**RECORD OF DECISION
FOR THE
TRANSFORMER STORAGE AREA
AT
NORFOLK NAVAL BASE
NORFOLK, VIRGINIA**

**Atlantic Division
Naval Facilities Engineering Command
Norfolk, Virginia**

**CH2M HILL
Reston, Virginia**

Section 6 RESPONSIVENESS SUMMARY

FIGURE 2-1
RI SOIL SAMPLE LOCATIONS AND ANALYTICAL RESULTS
TRANSFORMER STORAGE AREA
NORFOLK NAVAL BASE
NORFOLK, VIRGINIA

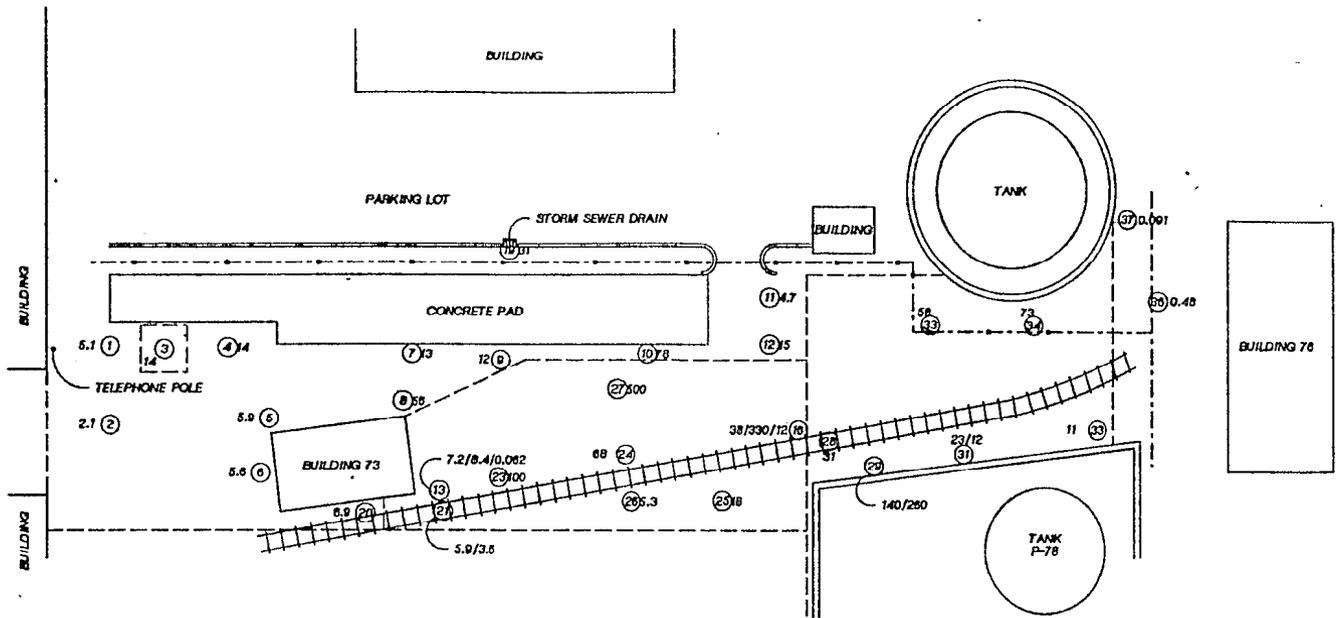
Comment: Figure 2-1 in the Draft *Remedial Investigation and Feasibility Study* (RI/FS) indicates an elevated concentration of PCBs in sediments at sample location 19, which is a storm sewer drain. The RI/FS and the Draft *Remedial Action Plan* (RAP) do not address the possibility of a release to Willoughby Bay due to stormwater runoff from this drain. Observed releases of PCBs in sediment have been recorded northeast of the Transformer Storage Area (TSA) at outfalls that empty into Willoughby Bay (Virginia State Water Control Board, 1991). The RI/FS should include analytical results from stormwater runoff at the drain, and identify the contaminant migration pathways associated with this drain. Analytical results for sediments along these pathways may also need to be provided in the RI/FS. The Baseline Risk Assessment portion of the RI/FS should address this possible PCB migration pathway and possible ecological targets, as described in Section 3.4 of the 1990 EPA guidance

on remedial actions for Superfund sites with PCB contamination (EPA/540/G-90/007).

Response: The Navy agrees that the potential for PCB contamination in the storm sewer drain does exist. In an effort to expedite the remediation of the TSA, which represents the primary source of possible PCB contamination in the storm sewer drain, the storm sewer drain and the entire stormwater sewer line will be investigated as a separate site. However, sediment samples will be collected from the storm sewer drain during the remedial action.
